## HISTORIC AND DESIGN REVIEW COMMISSION

**HDRC CASE NO:** 2016-453  
**ADDRESS:** 629 NOLAN  
**LEGAL DESCRIPTION:** NCB 547 BLK 19 LOT 17 AND 18  
**ZONING:** R-6 CD H  
**CITY COUNCIL DIST.:** 2  
**DISTRICT:** Dignowity Hill Historic District  
**APPLICANT:** Russ Tillery/Paradise Decks  
**OWNER:** Richard Garcia  
**TYPE OF WORK:** Construction of a side deck  
**REQUEST:**

**Historic and Design Review Commission  
Design Review Committee  
Report & Recommendation**

HDRC Case# 2016-453

# ELEVATION

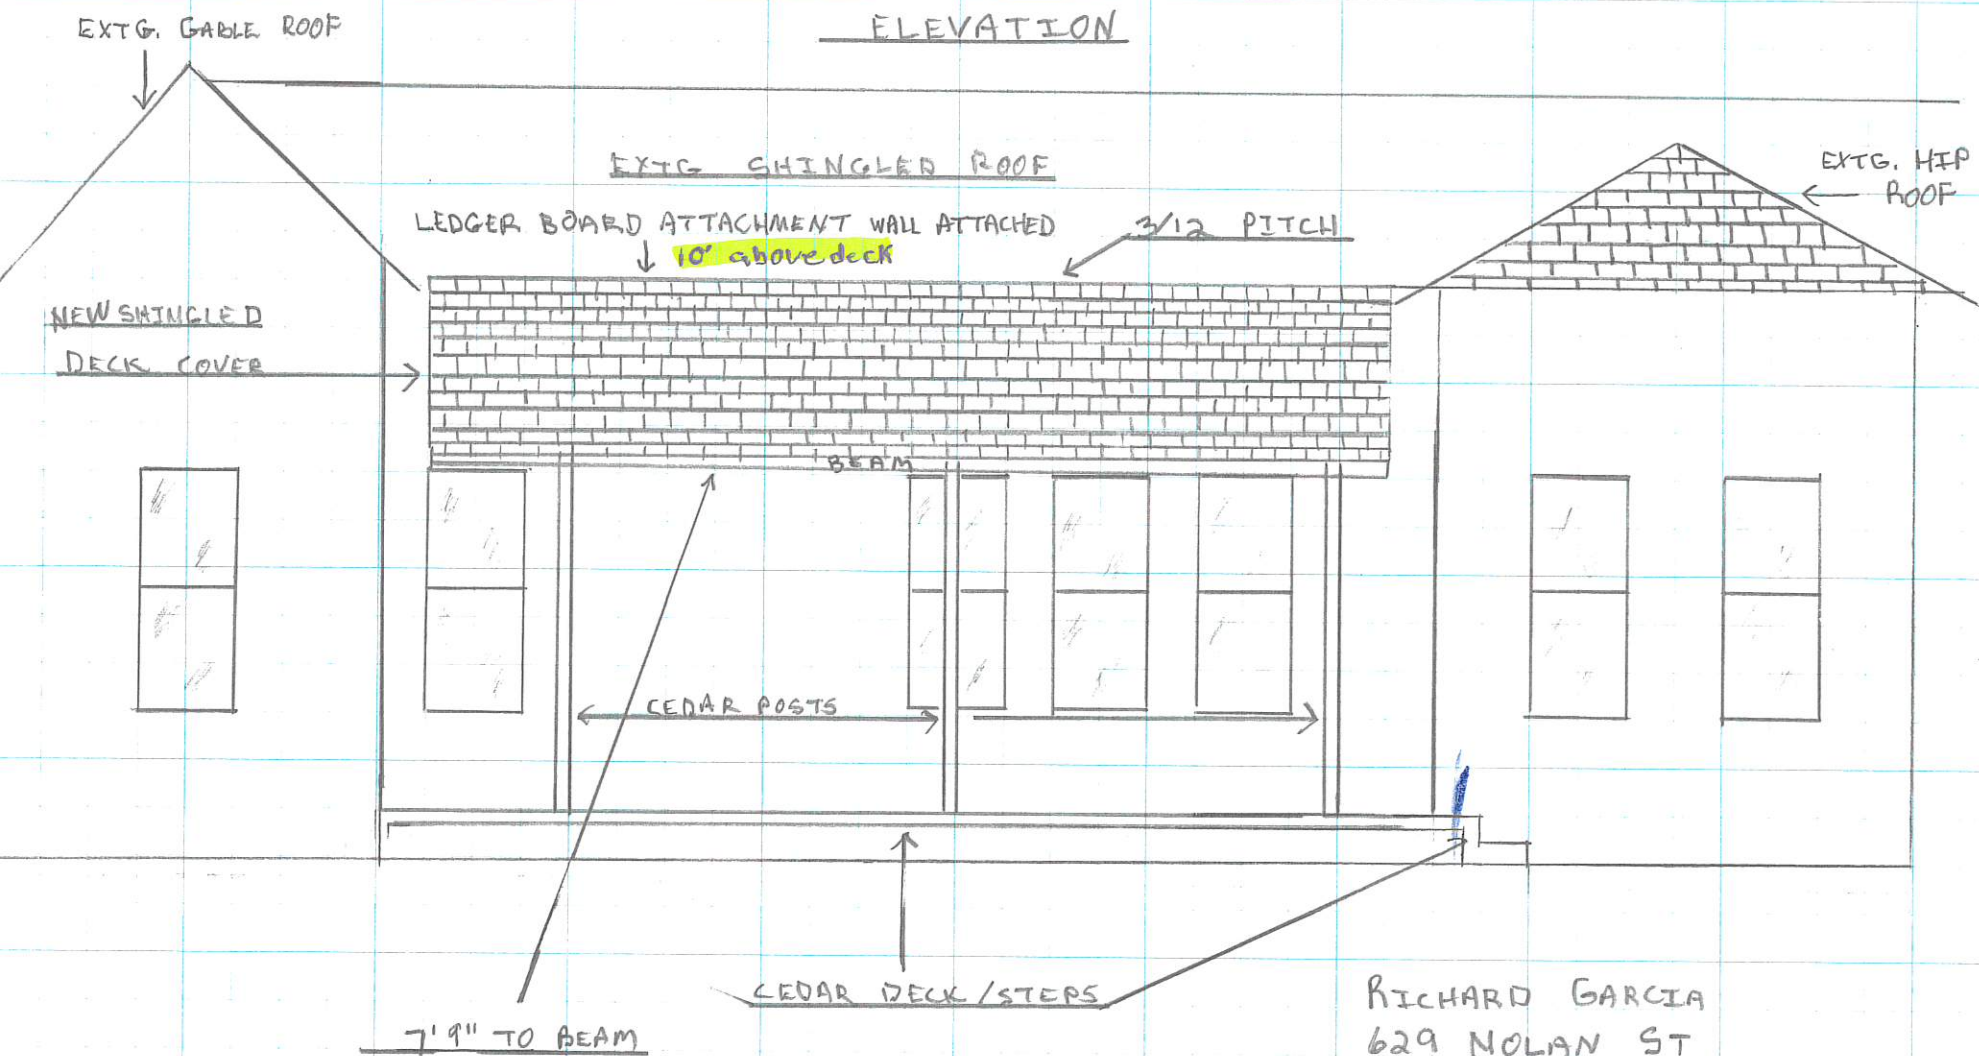
ON COLUMN DESIGN.

EG! A COLUMN WITH MOLINGS AND TRIM SHOULD BE INSTALLED.

EG! PROPOSED LEFT STEPS APPEAR TO BE SLIGHTLY UNREALISTIC, MAYBE THE DECK EXTENDS A FOOT FURTHER OUT.

EG! THE SPACING OF THE POSTS SHOULD BE REVIEWED.
